Appendix I Responses to the External Peer Review of the Proposed Desalination Amendment

Associated with the Draft Final Staff Report Including the Draft Final Substitute Environmental Documentation For the ~~Proposed~~ Draft Final Desalination Amendment

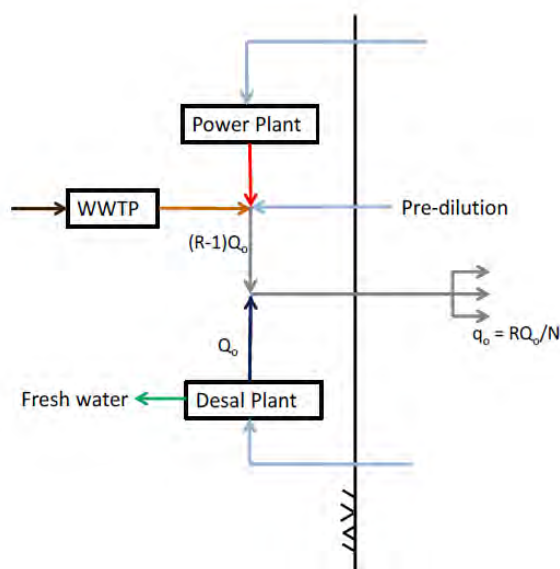
The above equations are for a single jet discharging just the brine from a desalination plant. The accompanying sketch depicts an arrangement where the discharged flow can be pre-diluted with either: i) seawater, ii) treated wastewater effluent, and/or iii) heated condenser cooling water from a power station, making a combined flow of RQ_o . The discharge is evenly distributed through N ports of a multiport diffuser making the flow per port equal to RQ_o/N . The reduced gravity of the combined flow is $[\Delta_o + (R-1)\Delta_p]/R$ where Δ_p is the reduced gravity of the pre-dilution flow, which is proportional to the pre-dilution excess salinity, i.e. $[g(\rho_p - \rho_a)/\rho_a] \sim \Delta s_p$, defined as positive for a dense flow. For example, if the pre-dilution comes from pure seawater $\Delta_p = \Delta s_p = 0$ while if it comes from treated wastewater effluent or heated condenser cooling water Δ_p and $\Delta s_p < 0$. Using Eqns 1b, 2b, the maximum plume height and the dilution are

Eqs 3-5 are exercised in the accompanying table. Note that for a given problem Q_o and Δ_o are fixed, while θ_o , R , u_o , N and Δ_p are design variables. Case 1 starts with base case parameters that do not meet a target near field dilution of 20 either for excess salinity Δs or excess concentration Δc (last two columns of the table). The remaining cases show that dilution increases (and a target of 20 can be easily achieved) by using a multi-port diffuser (increasing N ; Case 2), increasing discharge momentum (increasing u_o ; Case 3), pre-diluting the brine with neutrally buoyant seawater (increasing R with $\Delta_p = 0$; Case 4), and pre-diluting (co-mingling) the brine with relatively buoyant treated wastewater or heated water (increasing R and making $\Delta_p < 0$; Case 5).

So all of these options can provide improved dilution. On the negative side, increasing u_o and R may require deeper water depth or shallower discharge angle to avoid plume surfacing, while increasing N allows discharge in shallower water. These are capital cost issues. And increasing either u_o or R requires more pumping energy, an operating cost issue. Environmentally, increasing R causes more water to be withdrawn at the intake with potential impacts due to impingement and entrainment, as well as impacts on the discharge side due to turbulent shear. Increasing u_o by itself could also increase turbulent shear. But if you can use another effluent (i.e., treated wastewater or condenser cooling water) for pre-dilution, then you have already suffered the impacts with sourcing and using that water, and if you are going to discharge the other effluent to the ocean anyway, you might as well let it improve your dilution. In the case of treated wastewater, however, an evaluation should be made as to whether commingling is a more valuable use than re-use (direct or indirect).

To summarize, I certainly support the conclusion that diffusers and co-mingling can provide good near field dilution. Flow augmentation can also be used, but is somewhat less effective, and simply adjusting the exit velocity may also work. Because there are multiple environmental impacts to be minimized (intake entrainment/impingement, near and far field concentrations of
